HEAVY VEHICLE LOCAL ROAD REPORT

Sydney Metro West – Western Tunnelling Package

Clyde/ Rosehill

Document Title	Clyde/ Rosehill Heavy Vehicle Local Road Report
Project Name	Sydney Metro West – Western Tunnelling Package
Client	Sydney Metro
Document Reference No.	SMWSTWTP-GLO-CLJ-HS-RPT-000001-D.01
Revision Date	7 June 2022

DRAWING No: **CLY-SPA-07**
Semi trailer

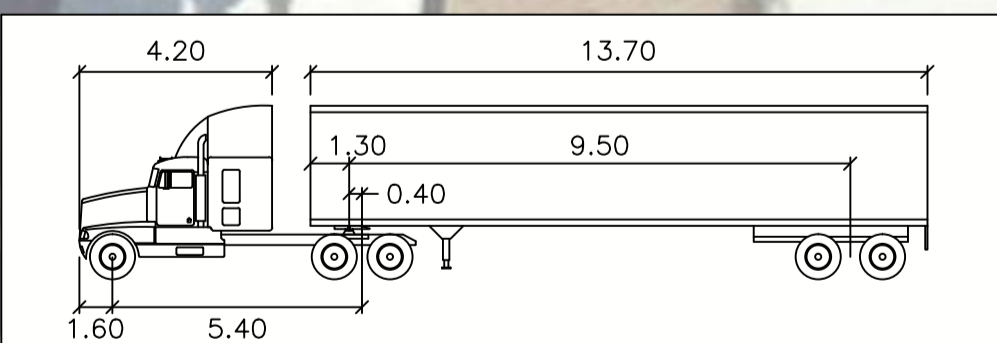
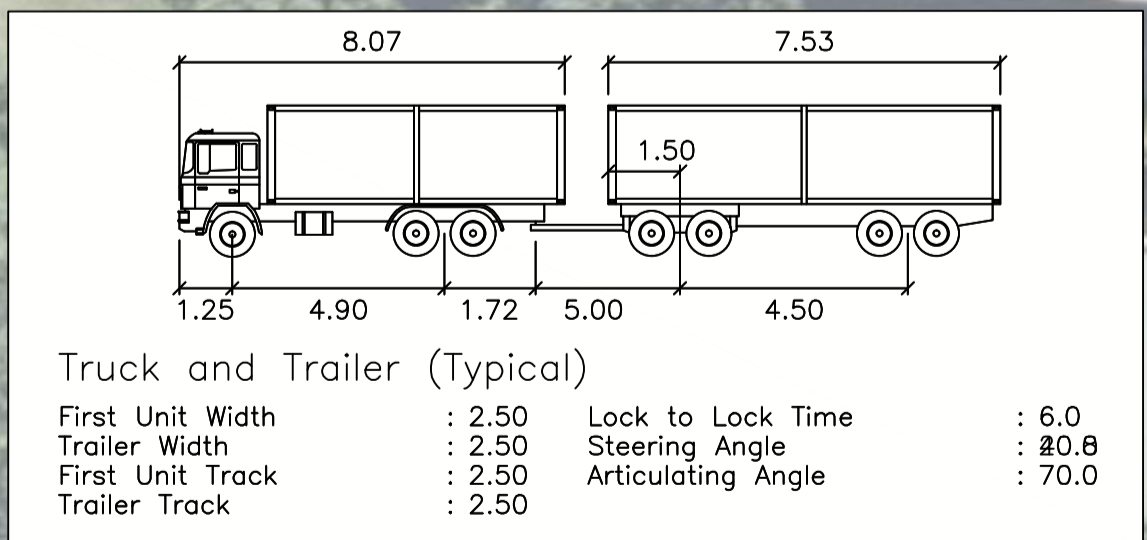
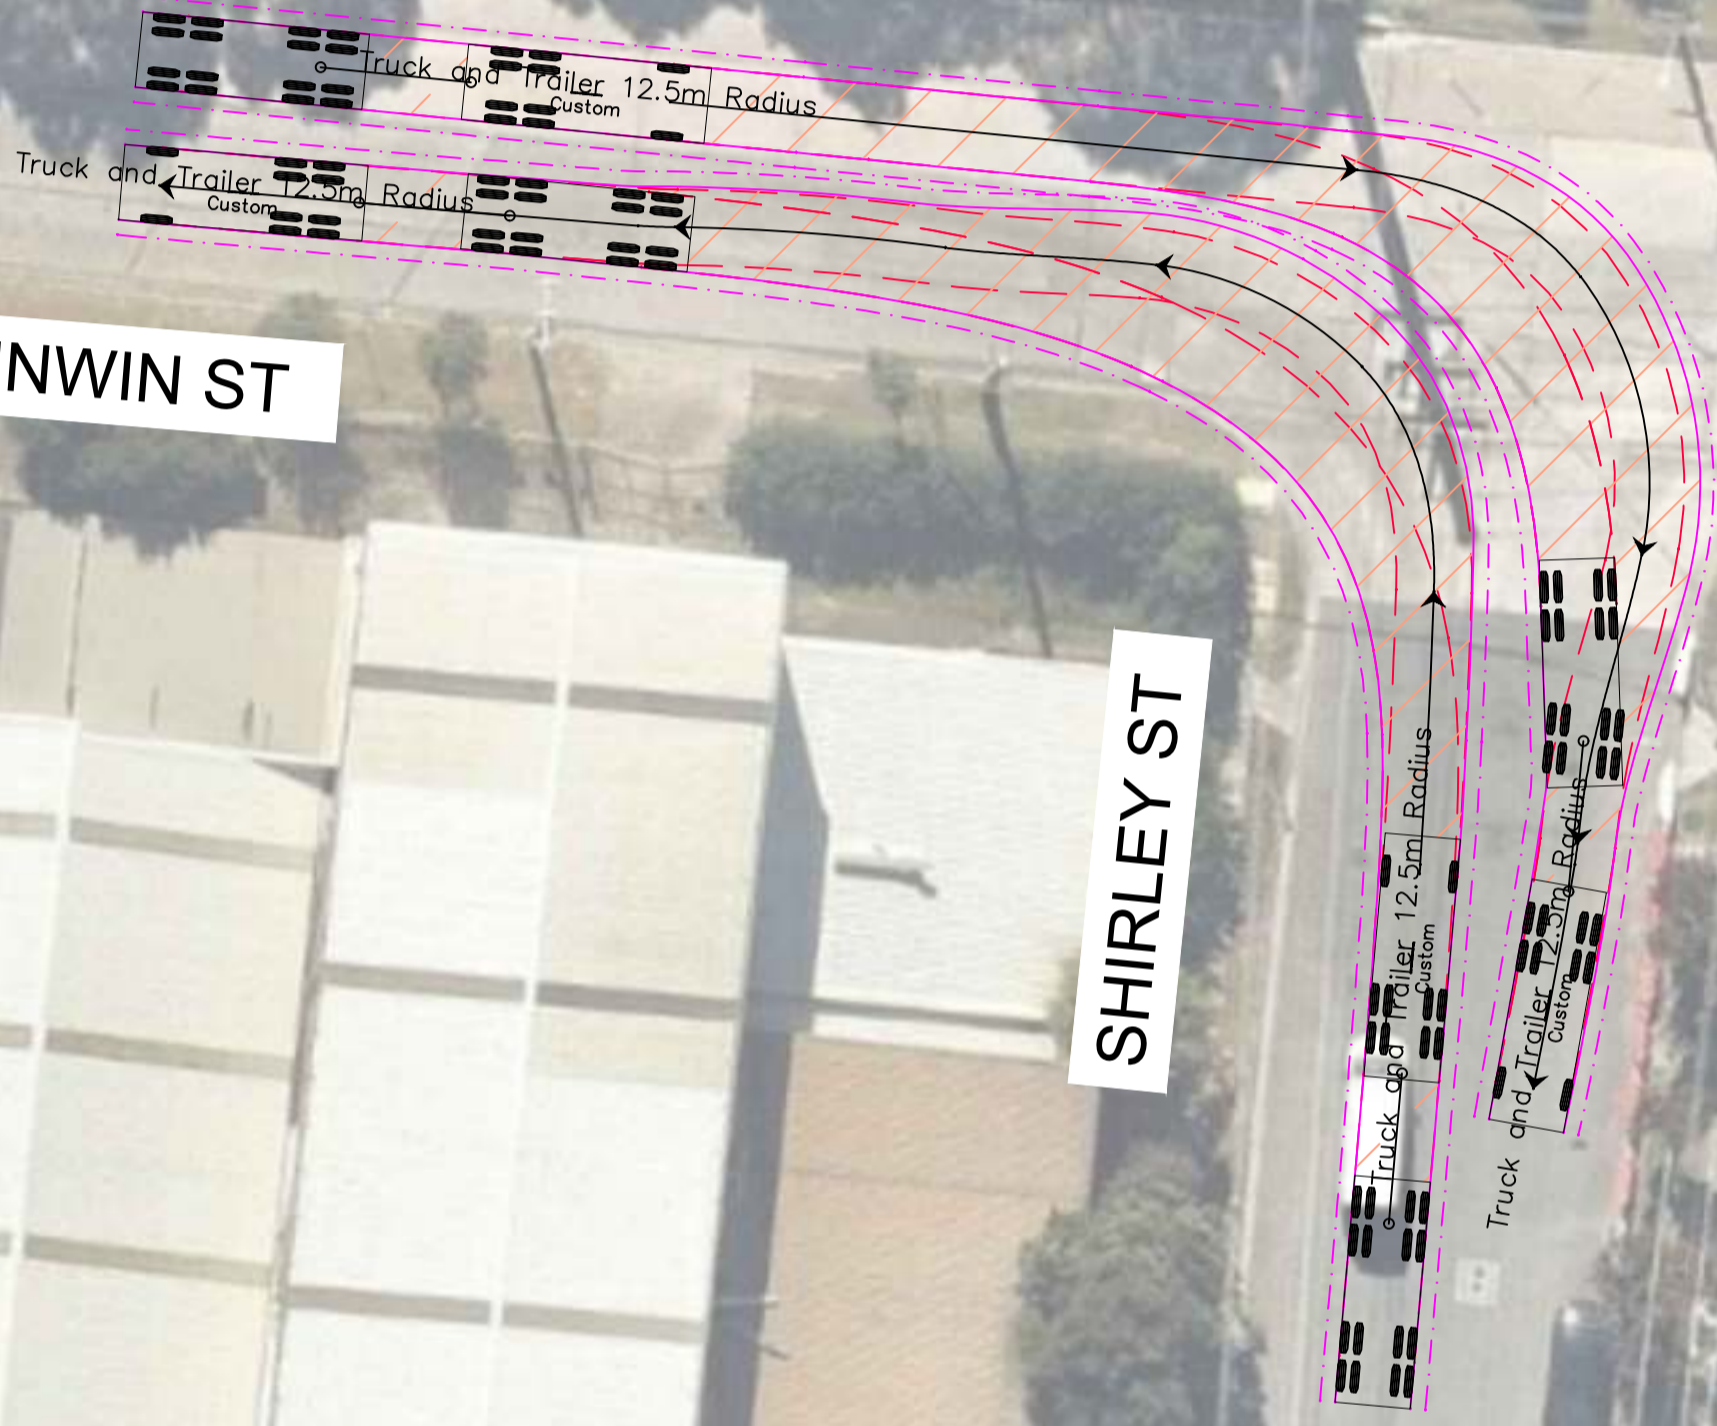
- Unwin Street onto Shirley Street;
- Martha Street onto Wentworth Street.
